Traffic Engineering Response to Council Information Request

To	BCB Solutions	Date	27 July 2026
Prepared by	Kevin Liu, Modus Traffic Engineer	Approved by	Harj Singh, Modus Executive Director (RPEQ 22364)
Location	875 Sandgate Road, Clayfield		
Subject	Proposed reconfiguration of an existing lot (ROL) into two (2) lots Development - Traffic Engineering Information Request Response		
Status	Final	Attachments	Appendix A: Council Information Request Appendix B: Modus Drawing Appendix C: Swept Path Assessment

Application Reference: A006806371
Address of Site: 875 SANDGATE RD CLAYFIELD QLD 4011

DRAWING NUMBER
MOD24105QLD - SK04

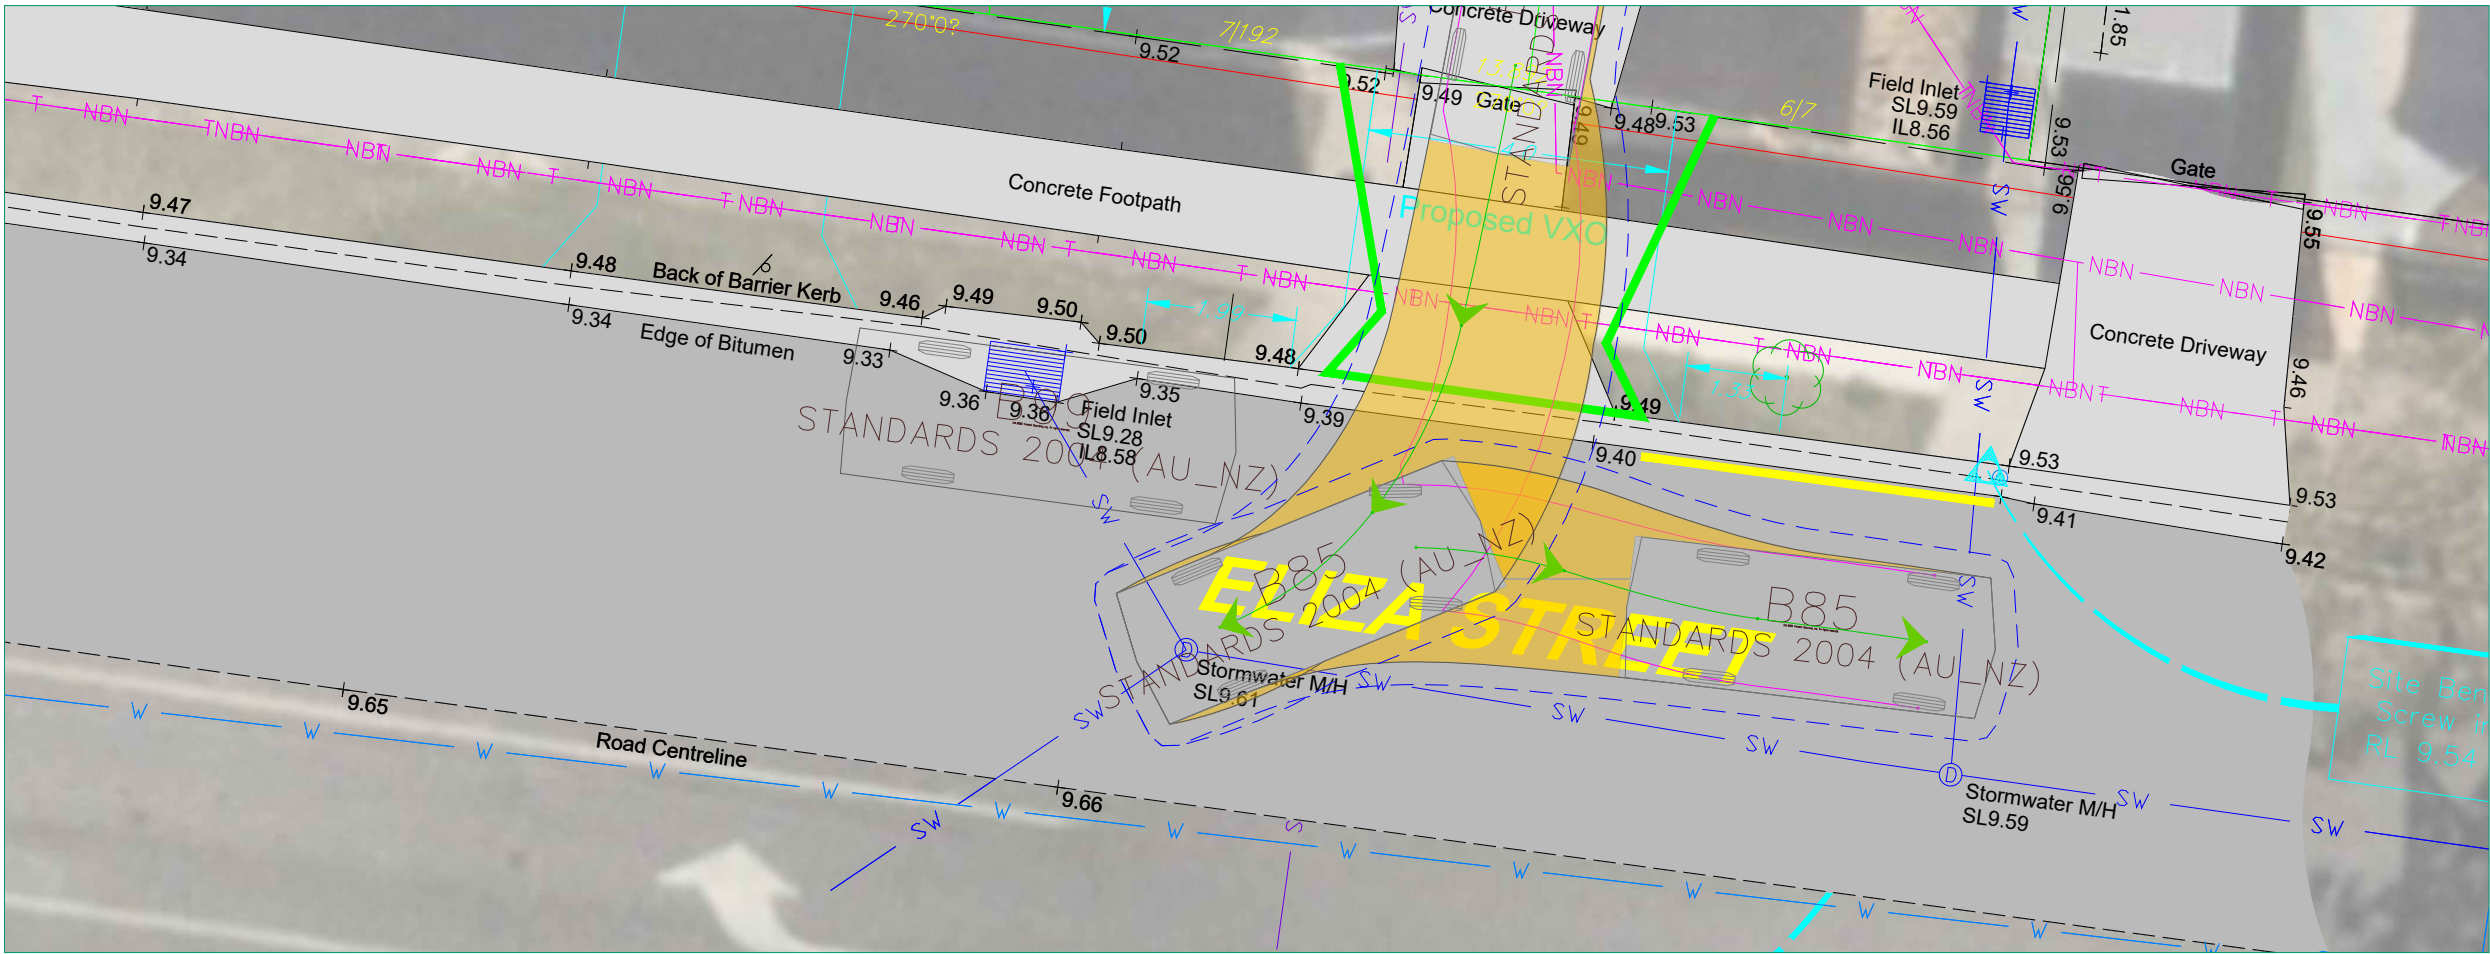
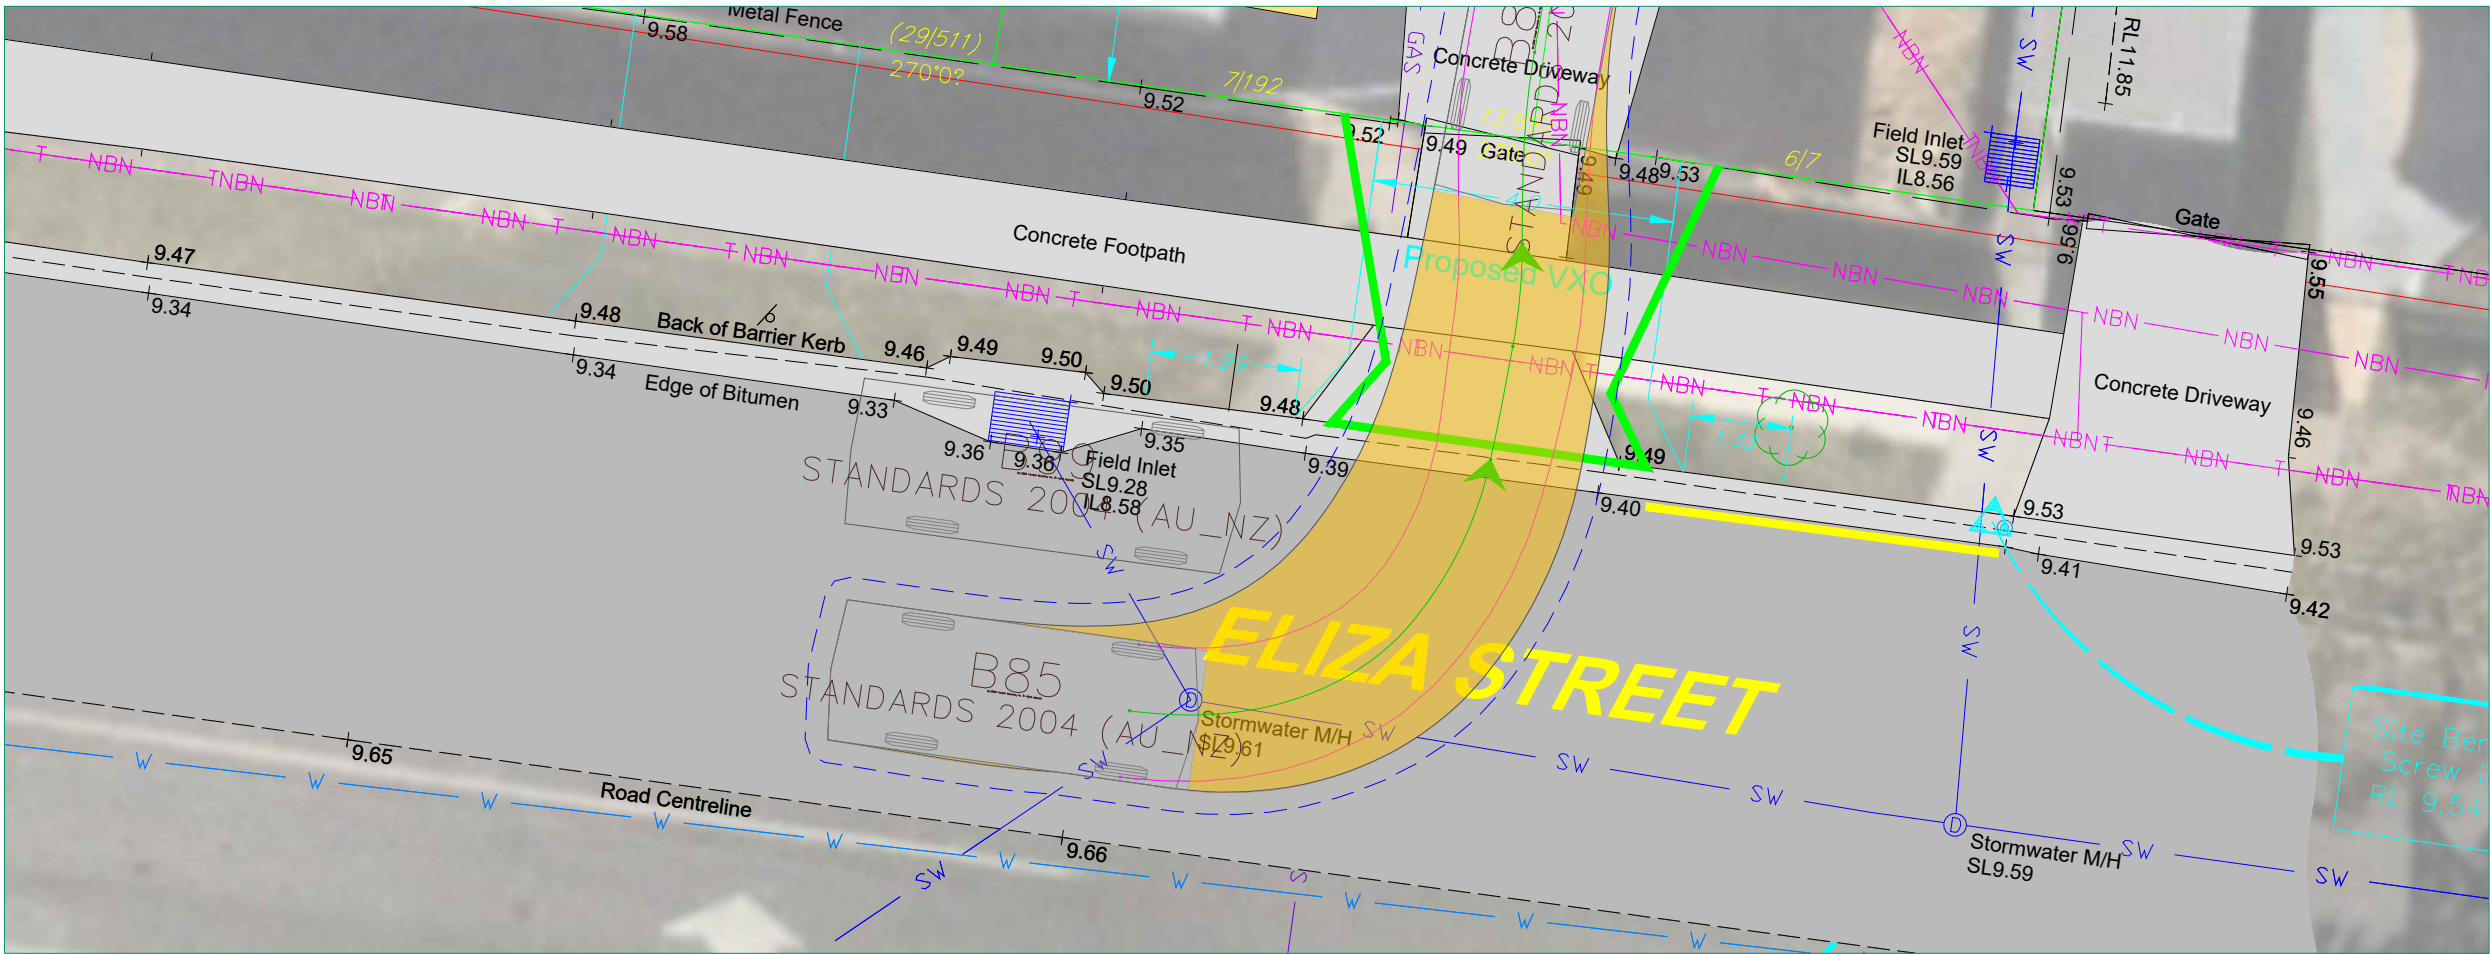
As the proposed small lot(s) has a frontage width of less than 10m, the development will need to demonstrate the proposed access or driveway is in a location that minimise impacts to existing street tree(s) and on-street car parking required under AO27.4 of the Subdivision Code. It is noted there are on-street parking along Eliza Street.

Provide amended plans, demonstrating the location of the proposed access or driveway will minimise any impacts to existing on-street car parking and street trees.

- a. Demonstrate the proposed development will not adversely impact on the on-street car parking on Eliza St. Provide RPEQ justification against any performance outcomes sought.*
- b. It is noted that an existing street tree is situated along the Eliza Street frontage within the Council verge. The proposed driveway appears to conflict with the existing street tree. Provide an amended site plan accurately depicting the location of the existing street tree(s), with dimensions and distances measuring from proposed driveway edge. Note: The driveway and its splays must be positioned at a minimum distance of 2m from the trunk of a cylindrical street tree, or 5m from the trunk of a buttress street tree.*

The proposed vehicle access has been positioned and restricted to a 3.0m width to minimise its occupation of the Eliza Street frontage, while providing functional access to the proposed lots. The crossover width is consistent with Council's current residential driveway guidance, which limits crossovers serving small lots to a maximum width of 3.0m under the self-assessment criteria.

The revised arrangement provides approximately 5.0m of kerb length to the west of the proposed crossover and approximately 4.9m between the eastern side of the crossover and the existing crossover serving 6 Eliza Street. The eastern section is constrained between two vehicle access points and would not provide a reliable, independently accessible kerbside parking opportunity.

The revised access arrangement has been positioned to maintain a minimum clearance of 2.0m between the outside face of the existing cylindrical street-tree trunk and the closest part of the proposed vehicle crossover, including its splay.

The revised plan identifies the tree location, trunk classification and relevant clearance to the proposed crossover. No removal or relocation of the street tree is proposed.
